DRAINAGE MEMO

**LOT 1, SPACE VILLAGE FILING NO. 3
6809 SPACE VILLAGE AVENUE
EL PASO COUNTY, COLORADO**

**May 17, 2018
PCD Project No. SP-17-009
Olsson Project No. 017-1754**

SPACE VILLAGE FILING NO. 3
 SPACE VILLAGE AVENUE AND PETERSON BOULEVARD
 EXISTING DRAINAGE BASIN MAP

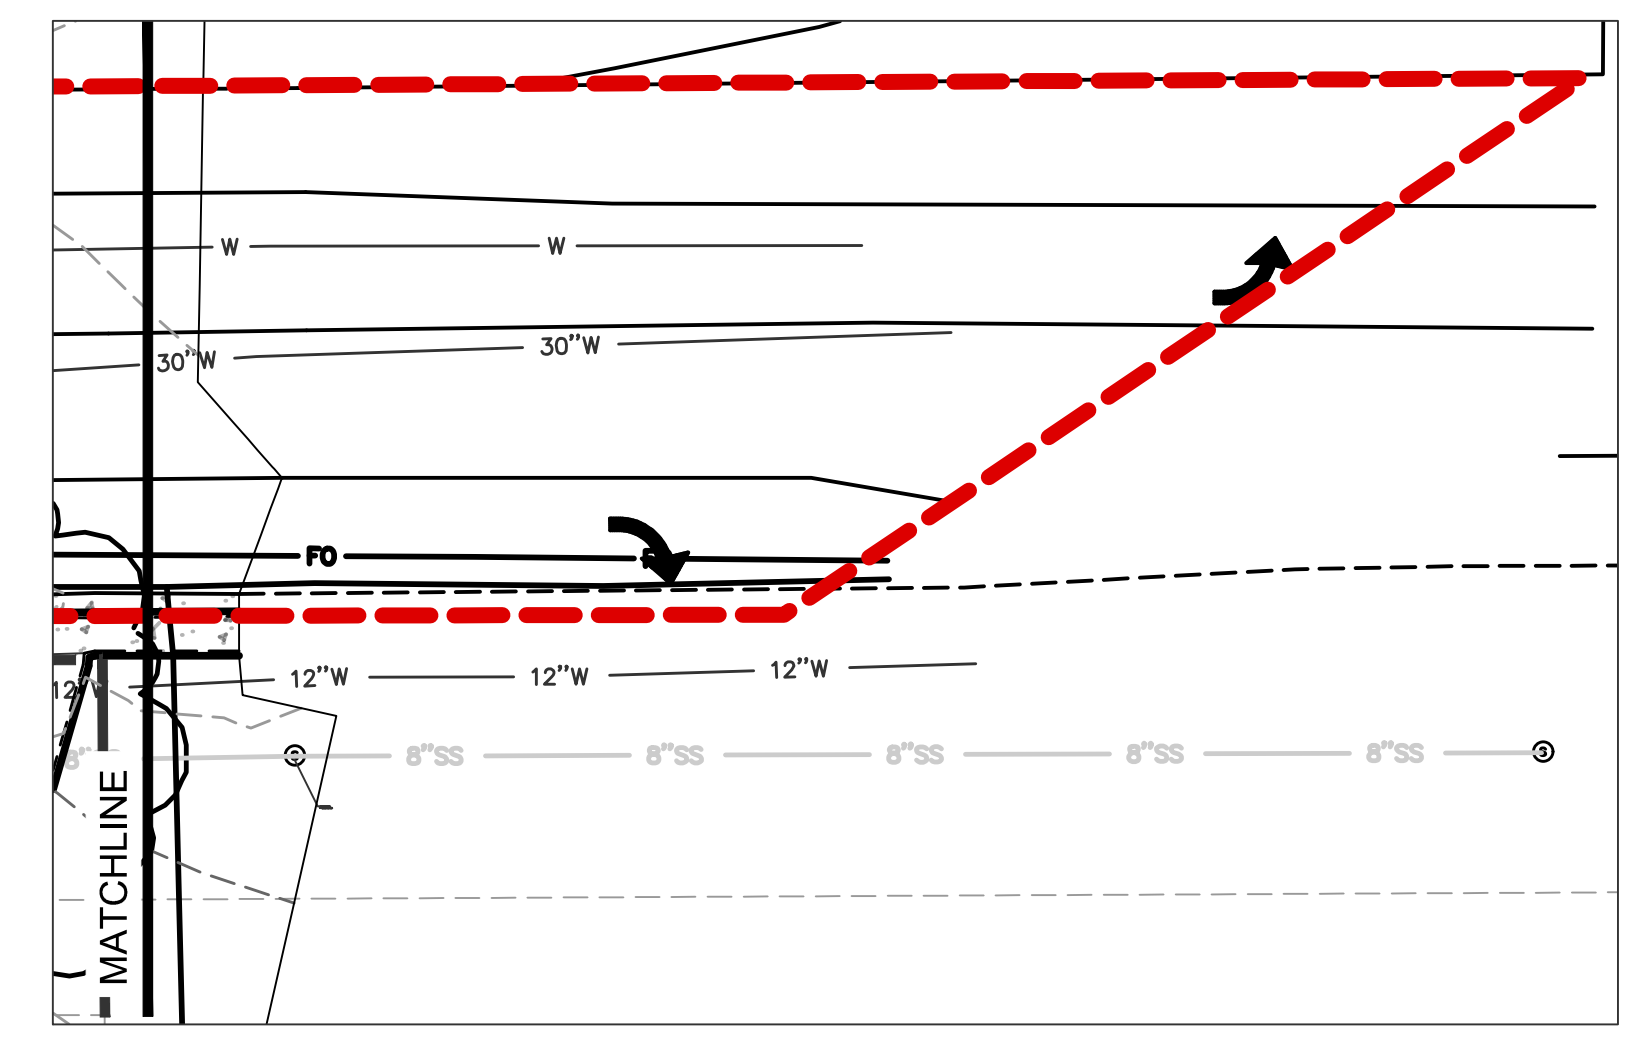
Expand the analysis to include the southern part of the subdivision. Analysis must be for the entire space village Filing 3 property.

Revise DP-4. Contributing Basins at DP 4 is EX-1, EX-2, EX-3

SPACE VILLAGE FILING NO. 3
 SPACE VILLAGE AVENUE AND PETERSON BOULEVARD
 PROPOSED DRAINAGE BASIN MAP

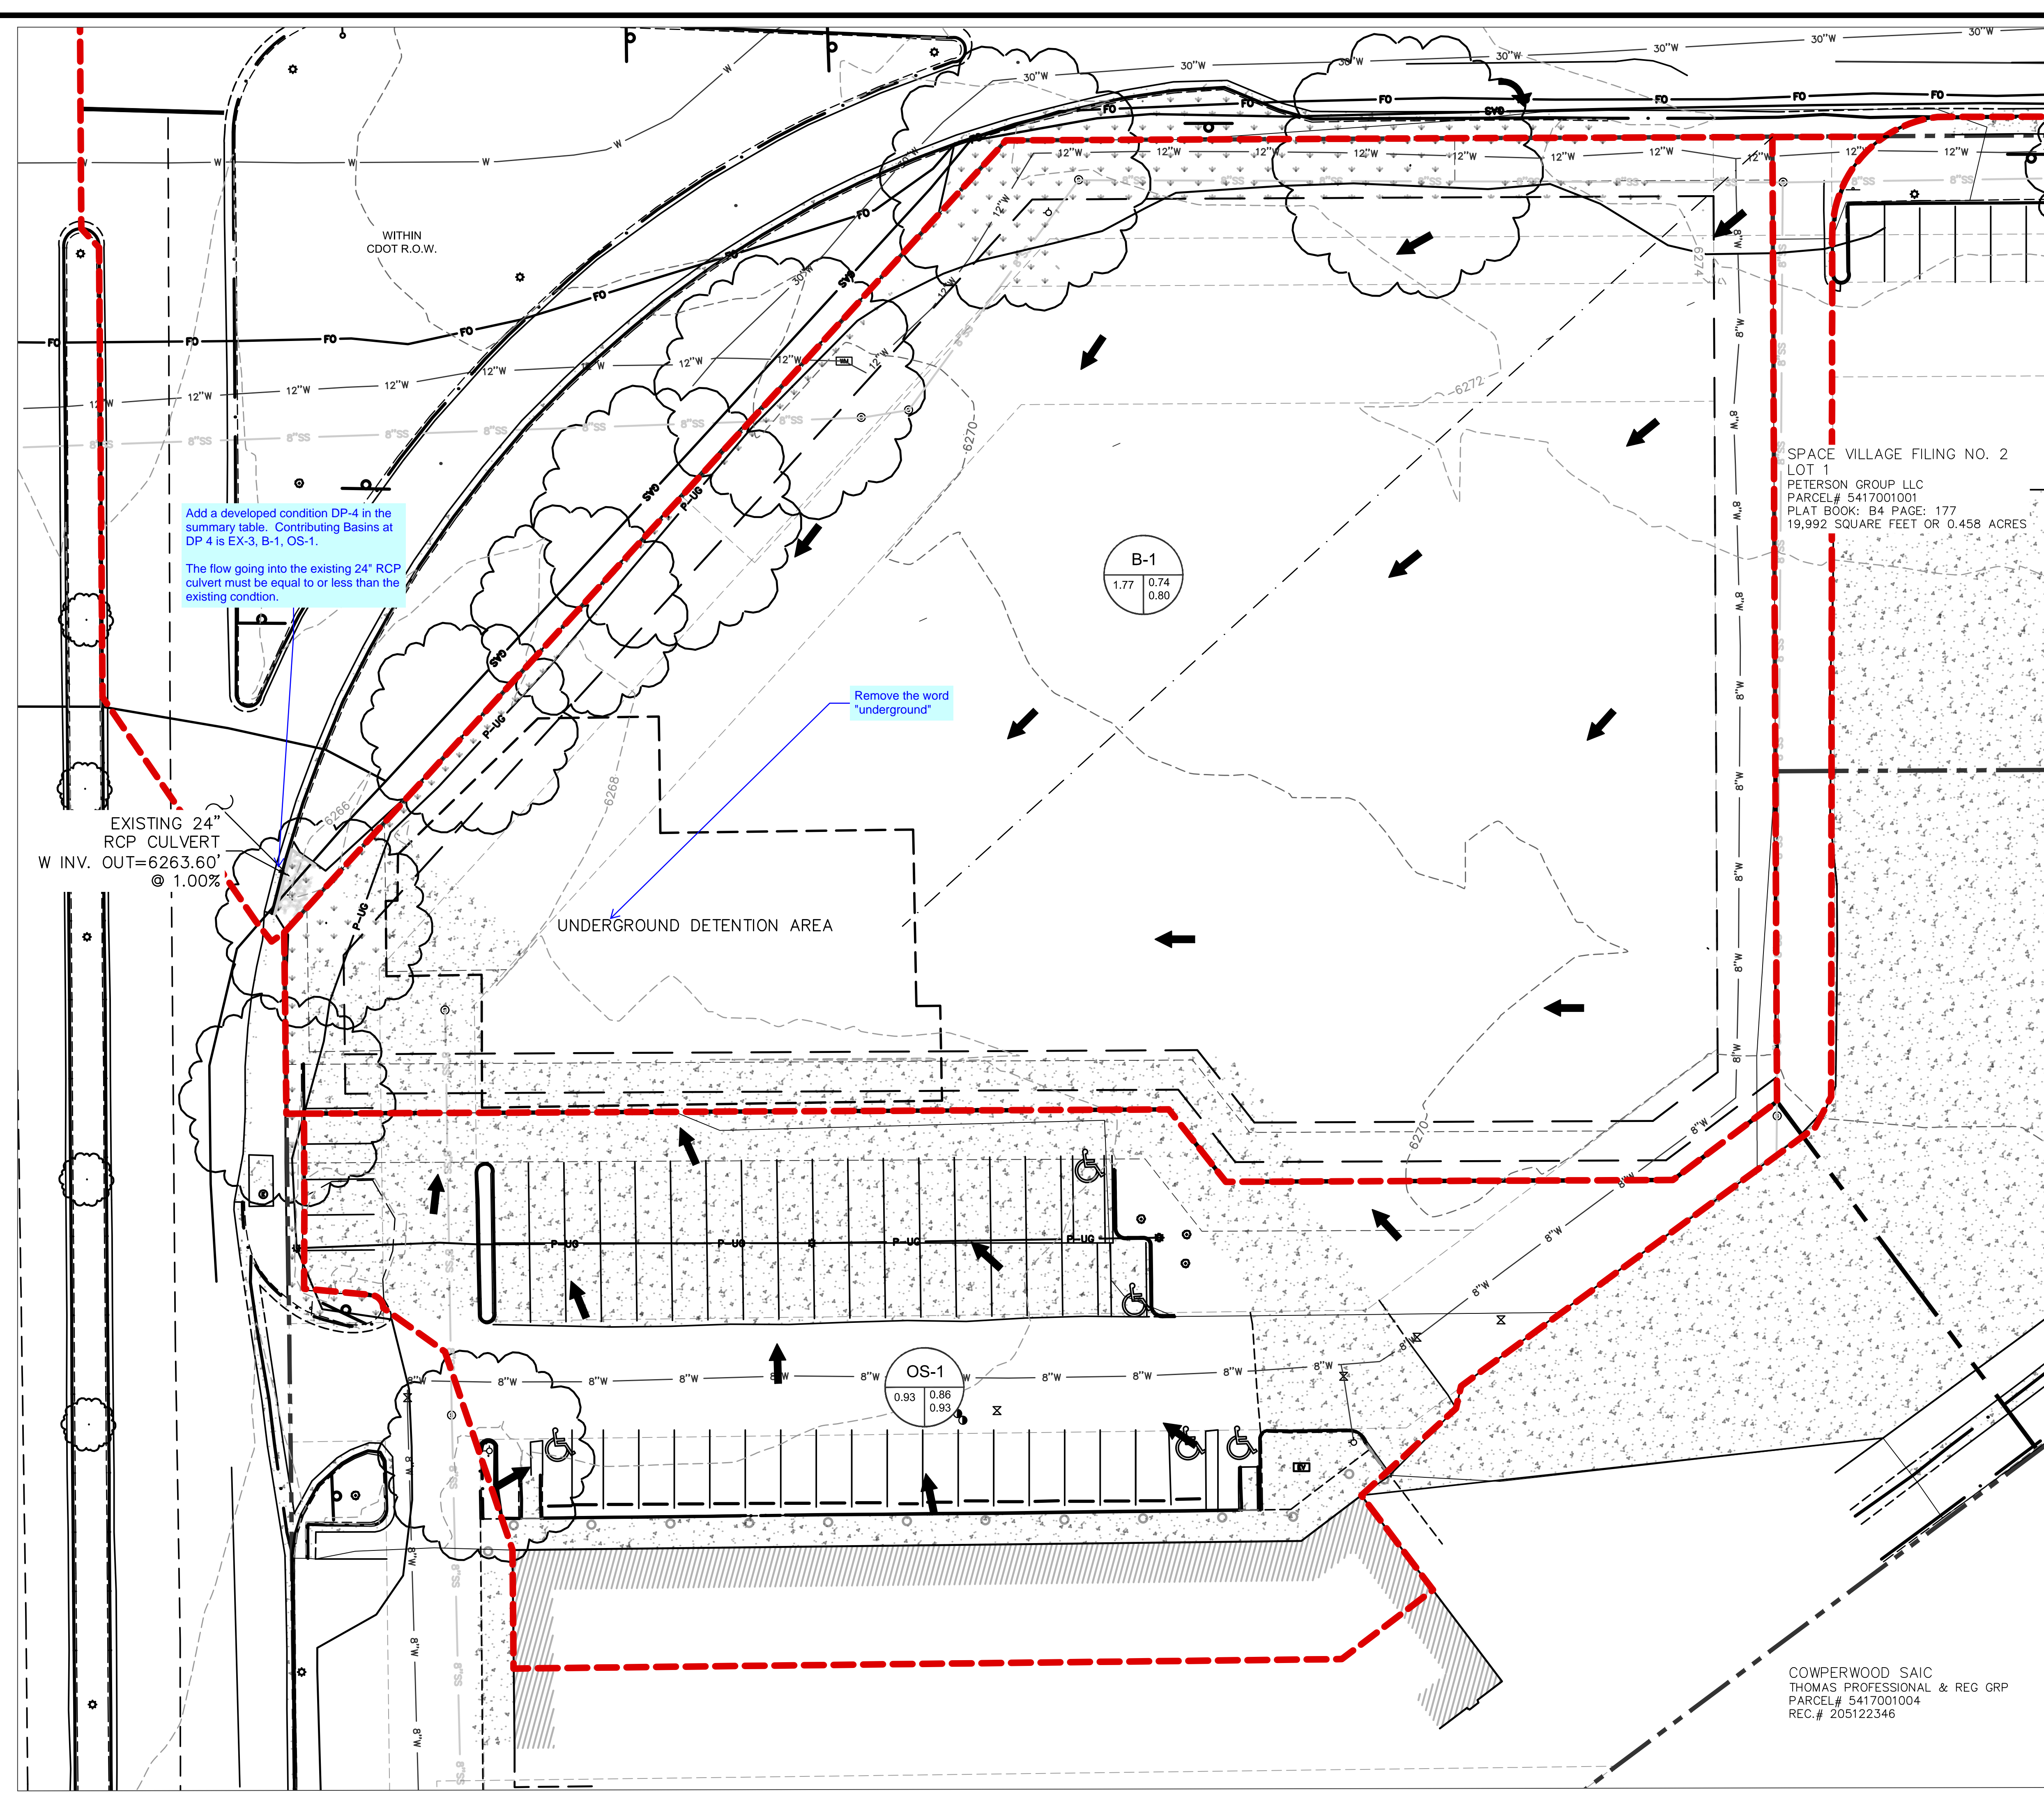
Add a developed condition DP-4 in the summary table. Contributing Basins at DP 4 is EX-3, B-1, OS-1.

The flow going into the existing 24" RCP culvert must be equal to or less than the existing condition.
